STAFF REPORT

AGENDA ITEM: **Variance – Direct Access for a Place of Worship**

CARMELITE MONASTERY DRIVEWAY FINAL GRADING UTILITY & STREET CONSTRUCTION PLAN LAKE ELMO, MINNESOTA

To:	Ken Roberts, Planning Director	Re:	Carmelite Monastery Driveway
Cc:	Marty Powers, Public Works Director Chad Isakson, Assistant City Engineer		Engineering Construction Plan Review
From:	Jack Griffin, P.E., City Engineer

GRADING PLAN

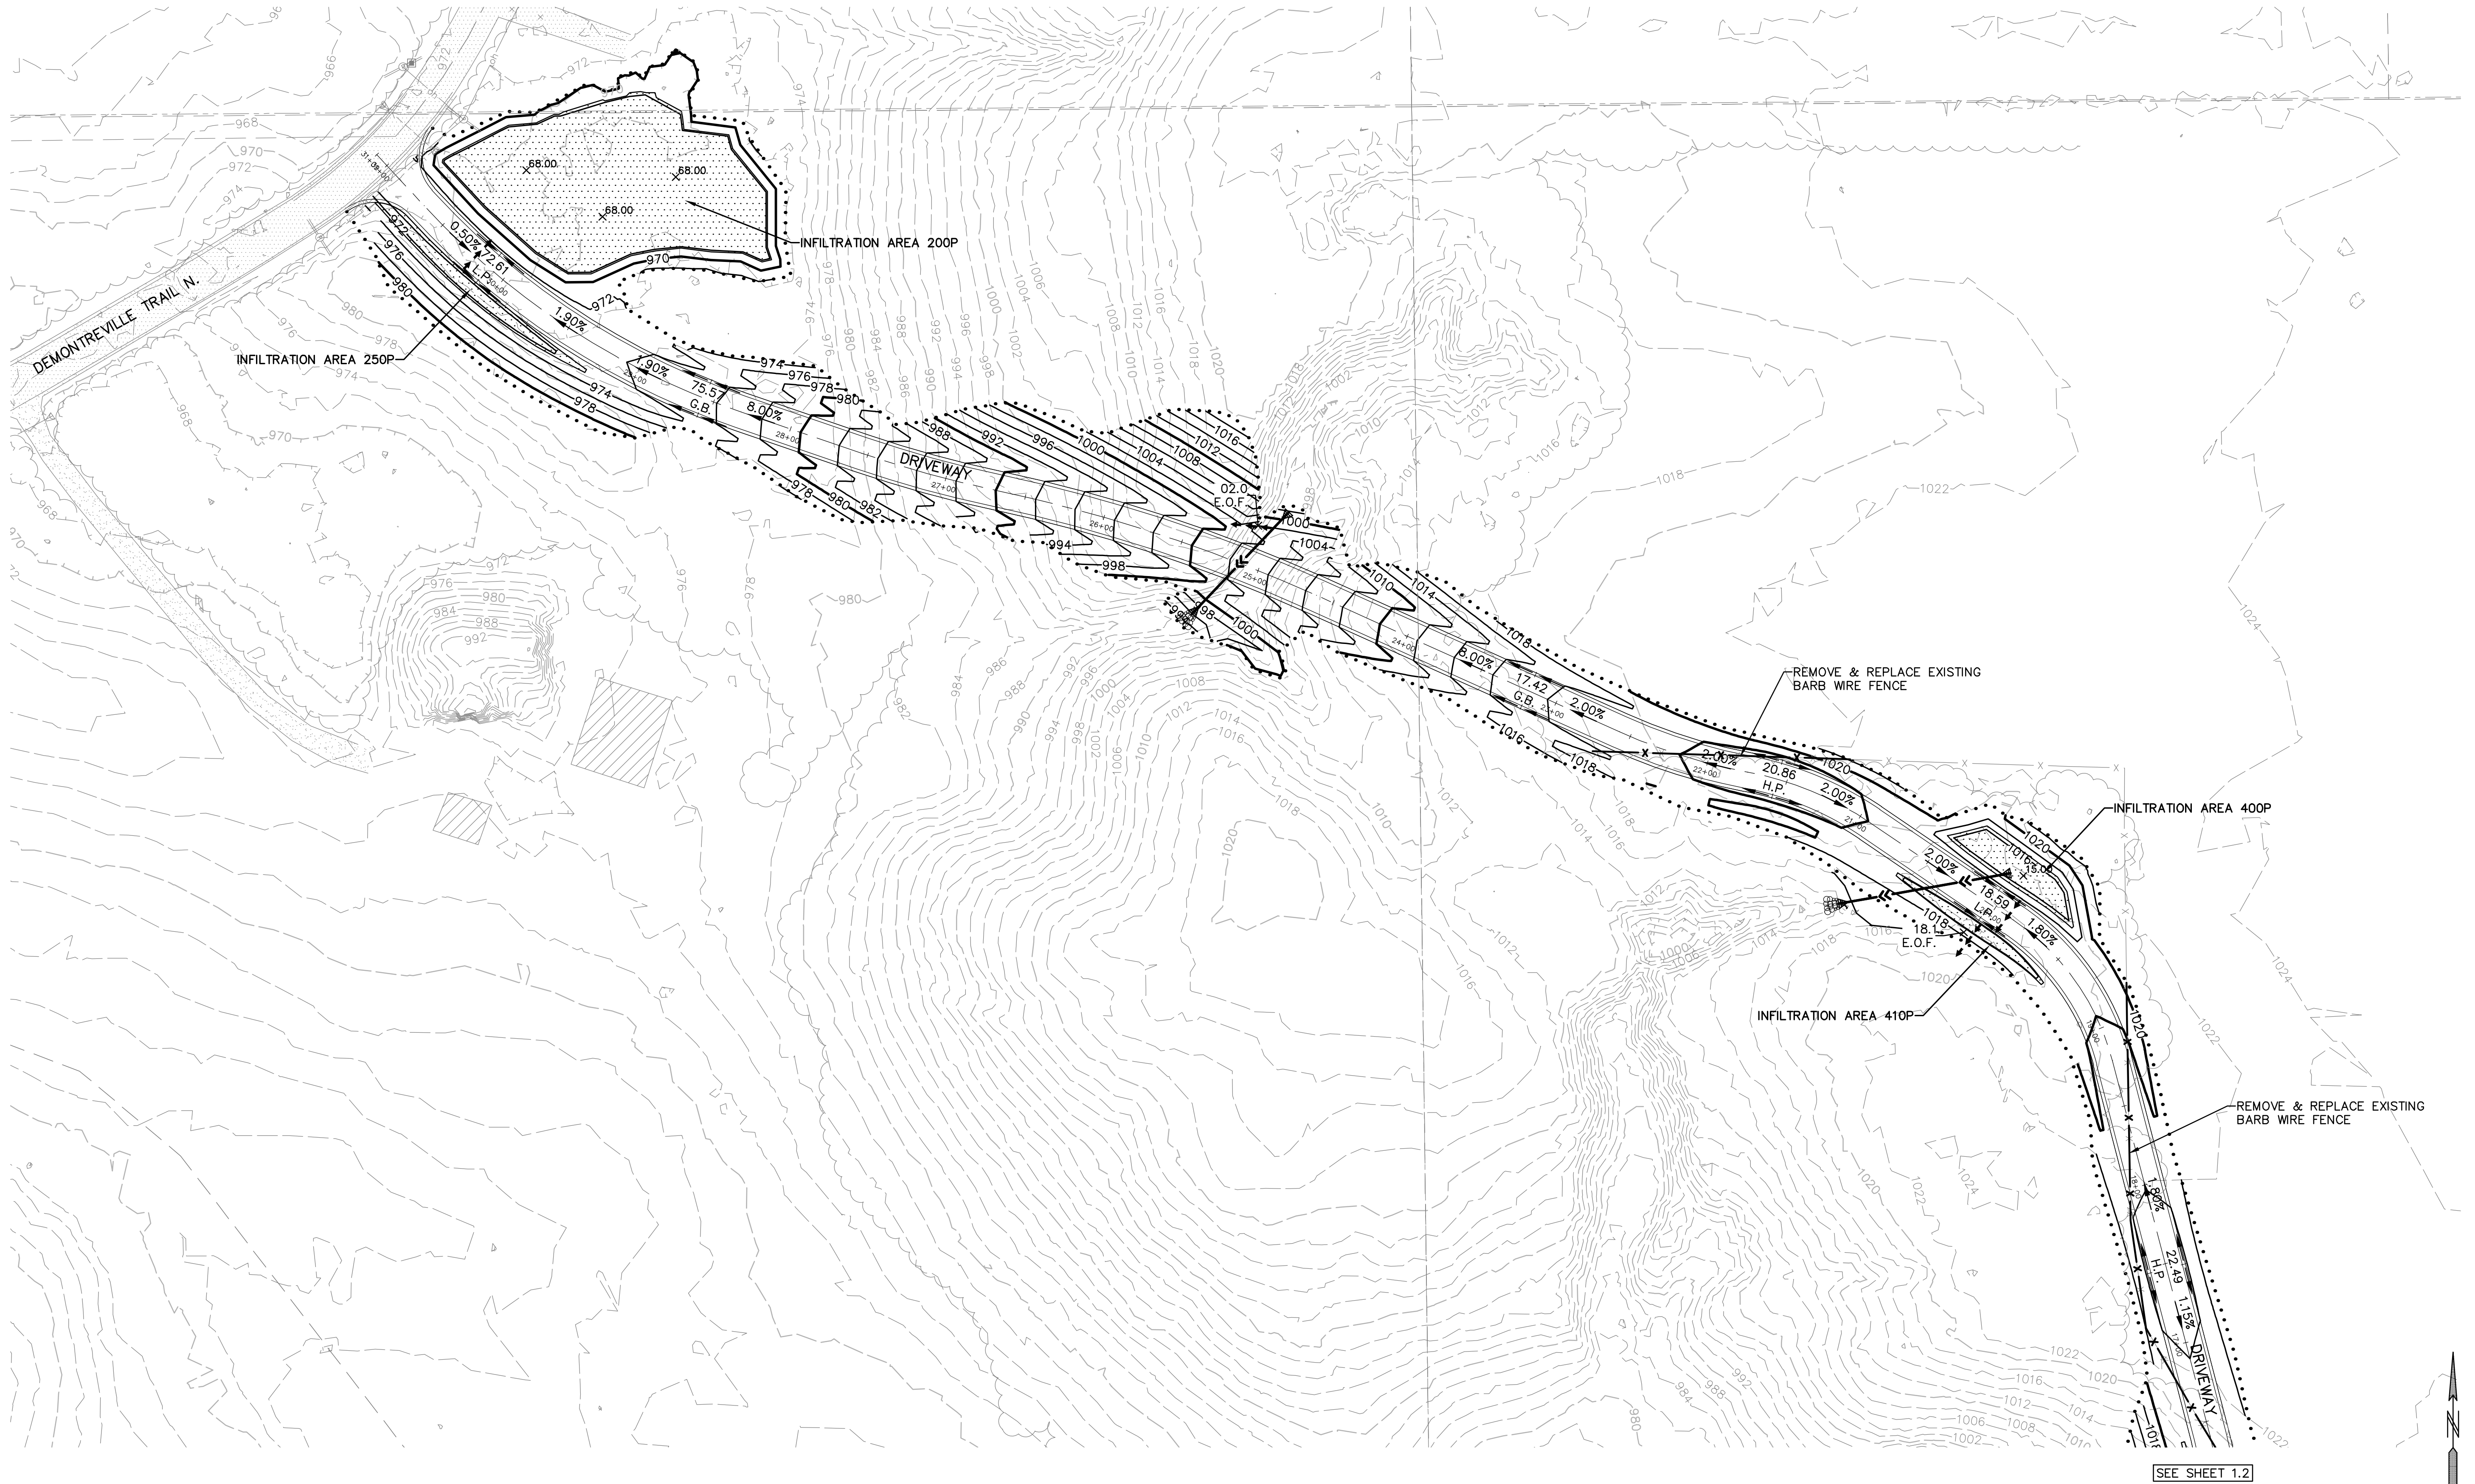
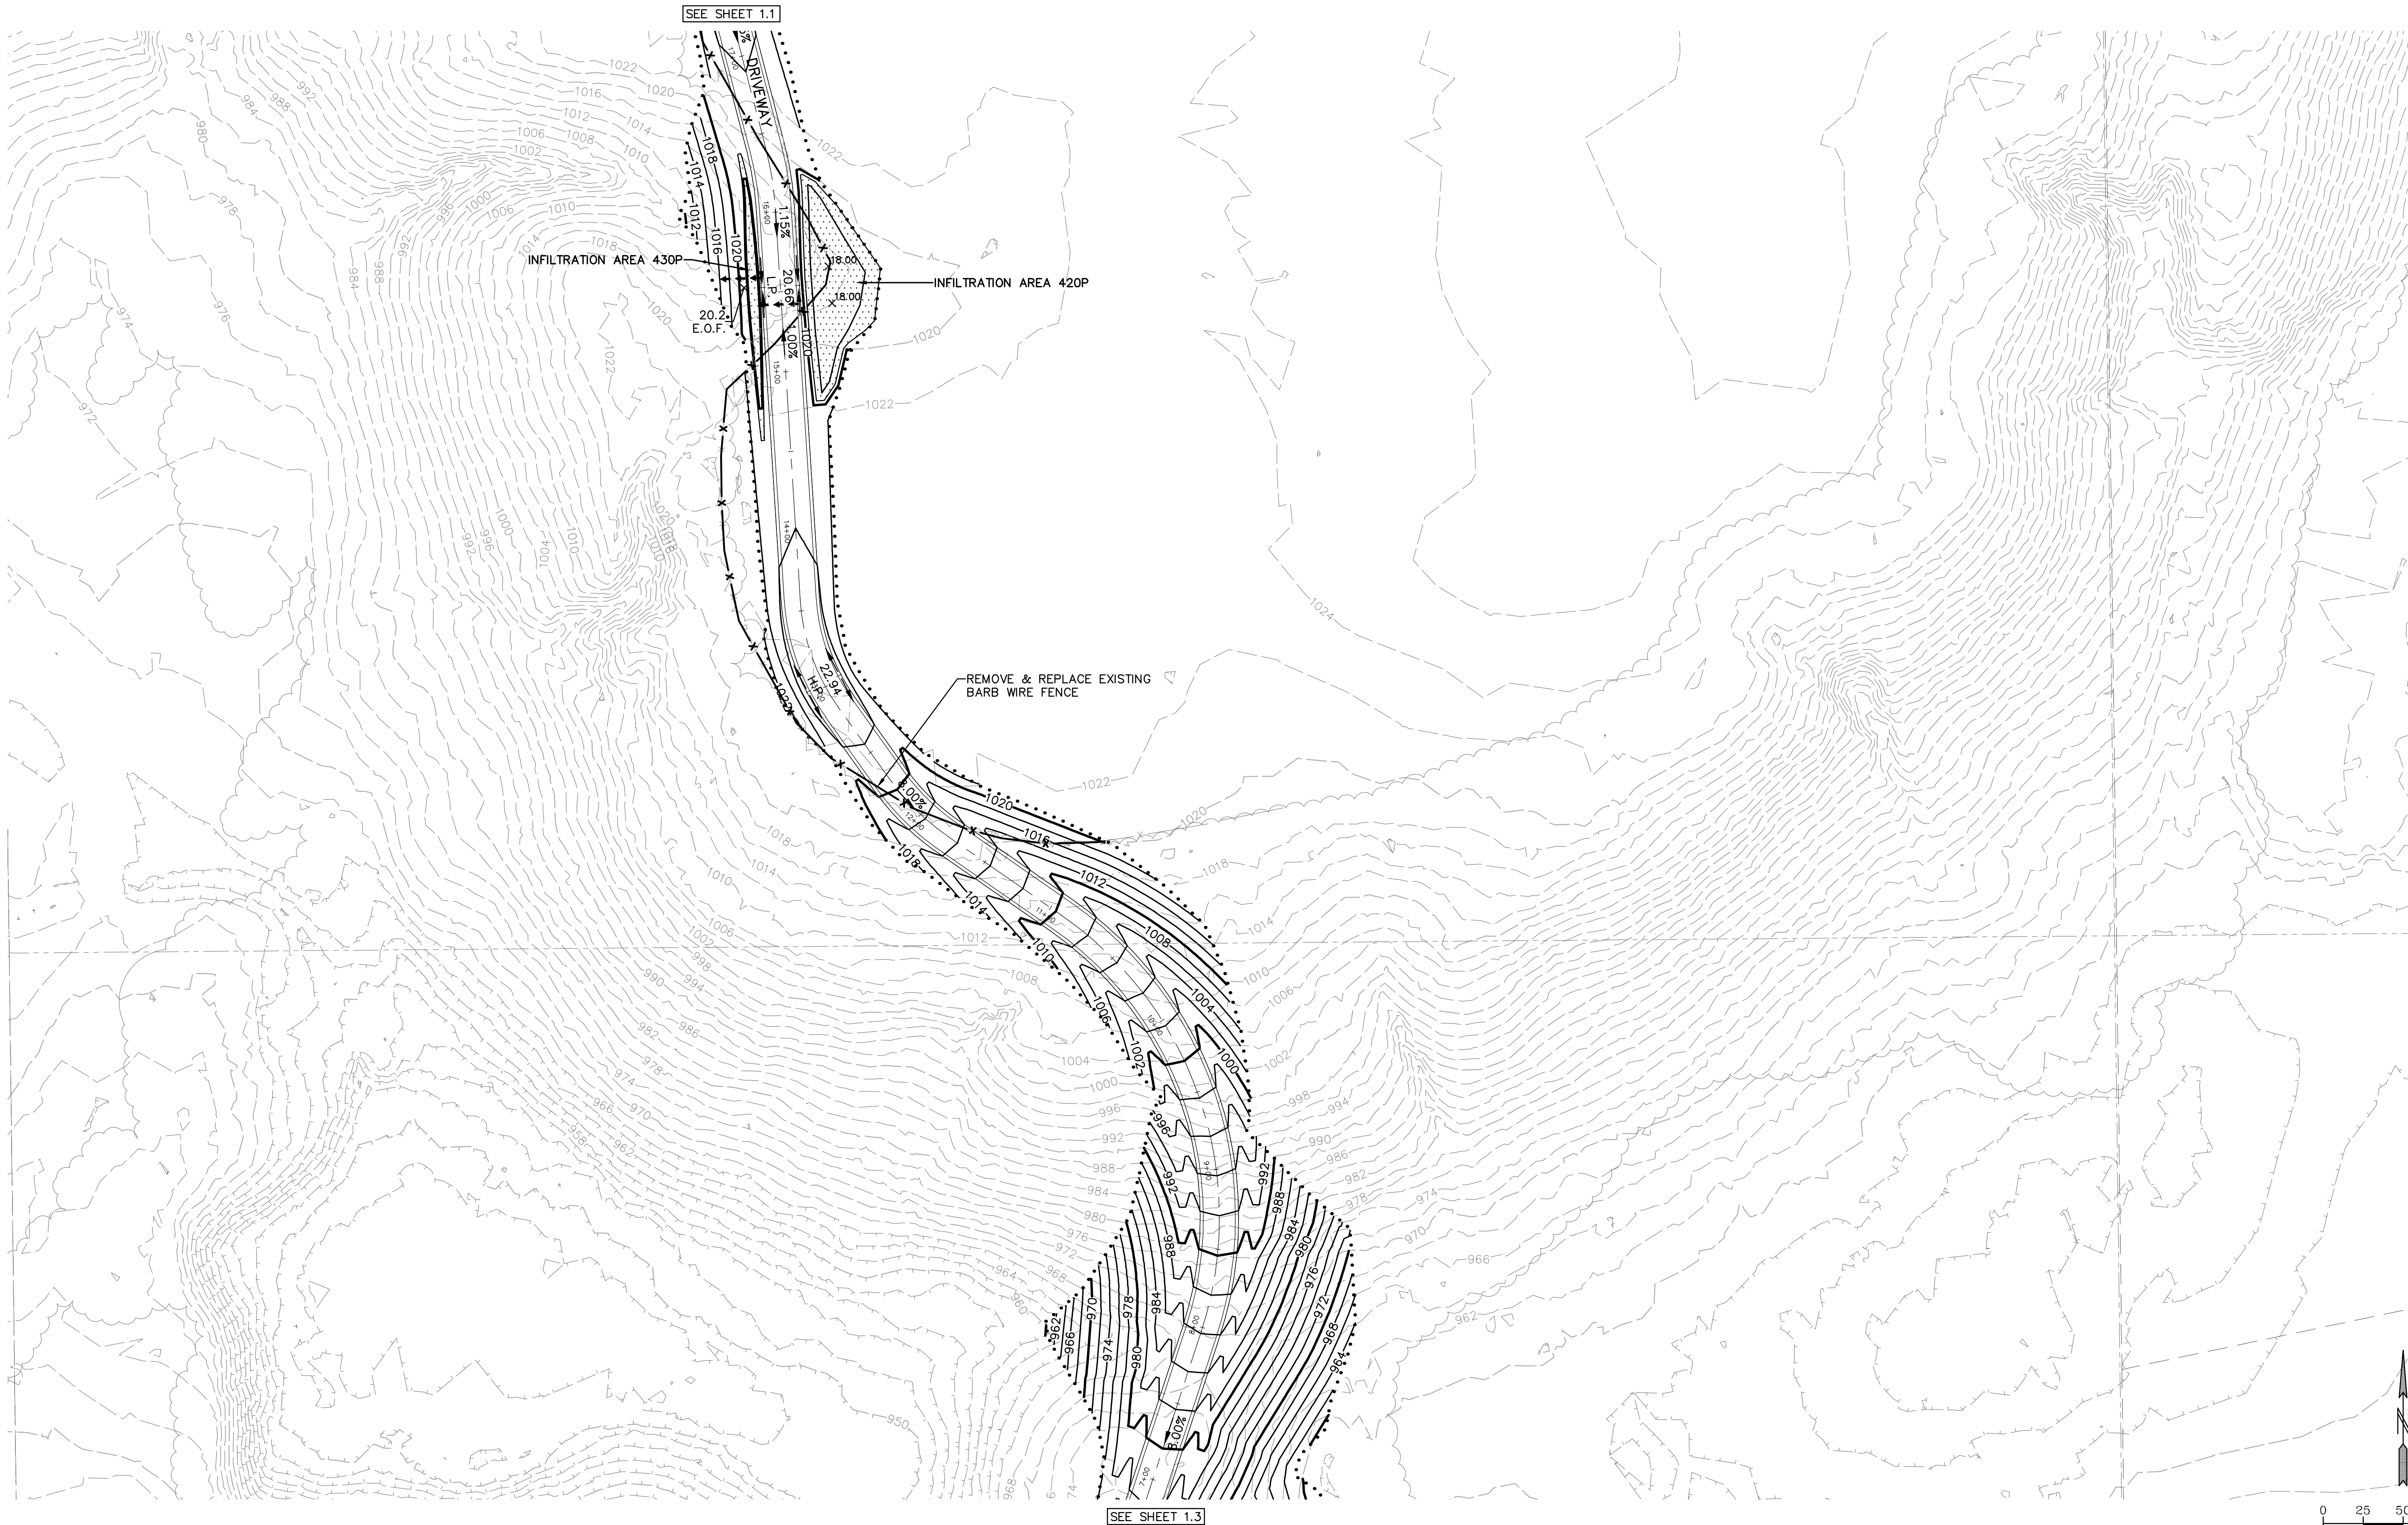
6. Sheet 1.1 – 1.3. Add culvert pipe size, material, and invert for all proposed and existing culverts.
7. Sheet 1.1 – 1.3. Add the 100-year HWL elevation and contour for all proposed infiltration basins. Add emergency overflow elevations and flow paths.

8. Sheet 1.1 – 1.3. Add proposed drainage and utility easements for each infiltration basin, incorporating the 100-year HWL elevation and contour, and maintenance access routes to all drainage structures.

9. Sheet 1.1. Revise grading plan to eliminate infiltration basin encroachments for areas 200P and 250P from the DeMontreville Trail right-of-way. Revise plans as needed to ensure the EOF flow path from 200P and 250P remain outside of the public right-of-way.
